Re: Heron Pond Condominium
Structural Conditions – Building #3

STRUCTURAL REPAIRS

BUILDING #3

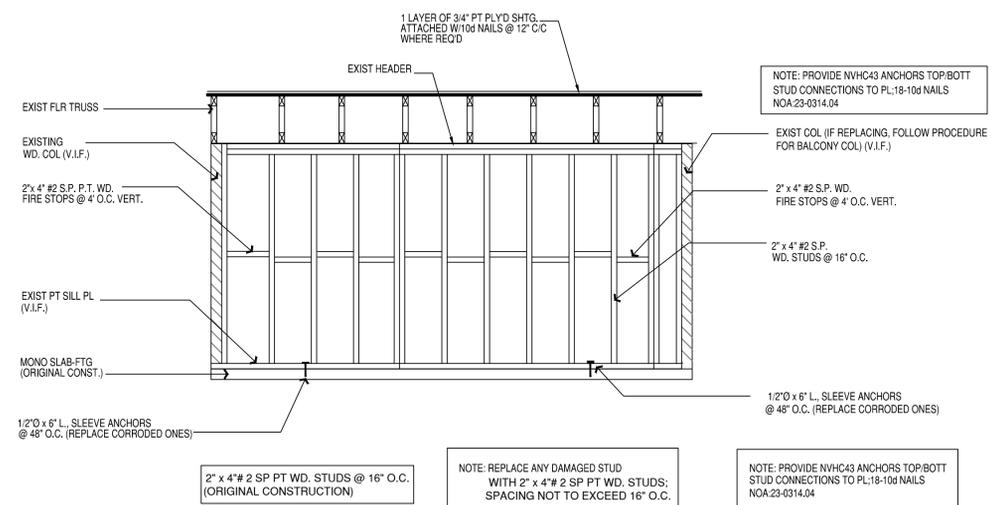
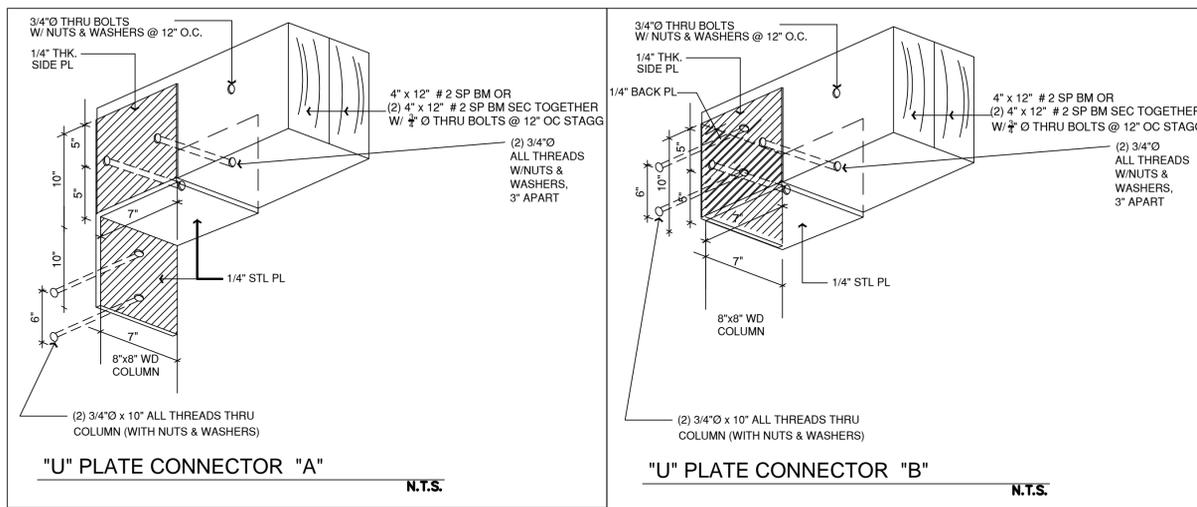
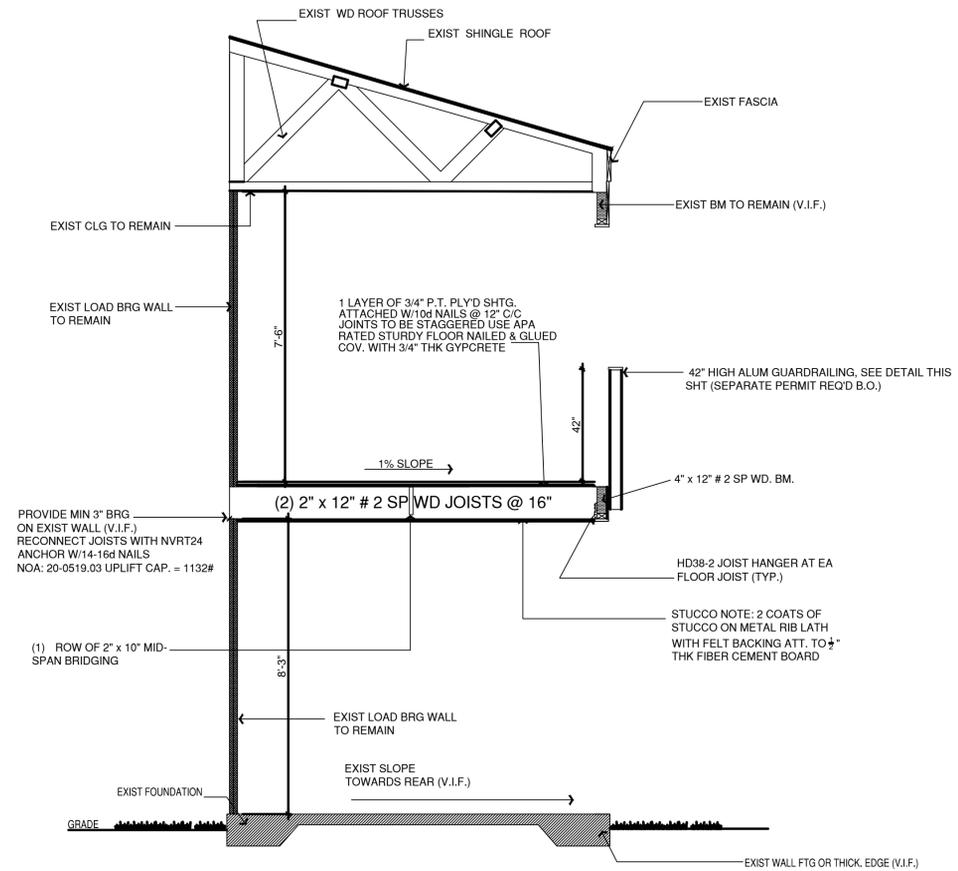
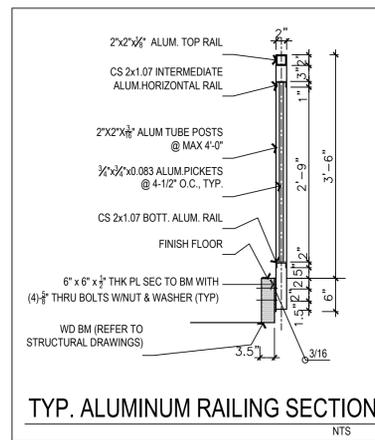
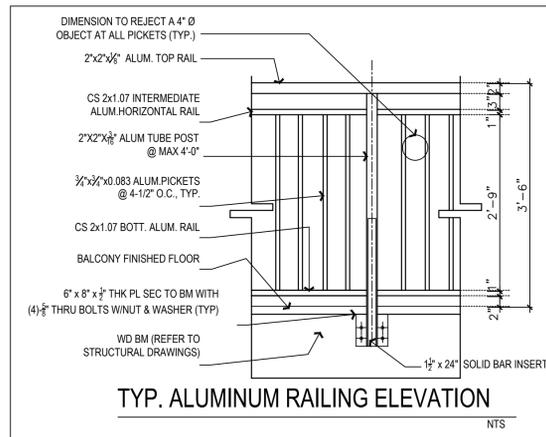
Over the last couple of weeks, a representative of ACG Engineering Services, Inc. (ACG), acting on my behalf, has surveyed Building #3 at the Heron Pond Condominium complex. We have attached a copy of the drawings that we will be having the Contractor submit as part of a permit application. Sheet S3.00, within that set, reflects our survey findings.

- The second floor is sagging in Unit #206.
- Ceiling damage is noticeable in Unit #206 as well.
- Ceiling damage is noticeable in Unit #204.
- There are at least 59 different locations around the building where damage has been visually detected, involving at least 15 out of the 16 units.
- Additionally, signs of previous repairs have been noted at 9 other locations around the building.
- There are signs of damage visible on all eight (8) balcony stacks.
- There are signs of damage to sections of exterior walls that appear to carry significant second floor and roof loads.
- There are at least seven (7) locations where damage has been observed in sections of the structure that clearly appear to have been recently repaired; in these locations fresh signs of damage are telegraphing through the finishes.

- The sagging of the second floor in Unit #206 is a likely sign that significant damage has been sustained by the floor members.
- The ceiling damages in Units #204 and #206 may reflect damage to roof trusses, particularly bottom chord members.
- Damage sustained by the exterior structural components, in the form of termite and water related wood deterioration, is clearly significant; the likelihood of termite and/or water related damage extending into the building's interior is considerable.
- Of additional concern is that 10% to 15% of recently repaired sections are already showing new signs of deterioration.

- All of the balcony stack structures, including joists, beams, and columns, have sustained significant structural damage.
- Some of the apparently compromised sections of exterior wall appear to carry considerable 2nd floor and/or roof loads.

- Access to Units #206 and #106 must be eliminated until repairs have been made to the sagging section of the floor structure.
- The floor of Unit #206 and the ceiling of Unit #106 should be removed in order to allow for complete repairs to be made to the floor structure in the area where sagging exists.

- The ceilings of Units #204 and #206 must be removed to allow for observations to be made of the roof truss conditions in the vicinities of the noted damaged ceiling areas. Repairs must be made as necessary.

- All access to all balconies (both levels) must be eliminated until repairs have been made.
- All balcony ceilings should be removed to allow for visual observations of the second floor and roof structures.

- All second-floor balcony structures should be rebuilt.
- All roof trusses over the second-floor balconies shall be repaired as required.
- Damages that extend into the interior of the building must be identified and repaired upon discovery.

- Wall bulges, cracks, and delaminations must be removed and those wall sections repaired in accordance with the loads that they carry.
- Based on findings from the explorations to be performed, as described directly above, individual units may need to be completely vacated.
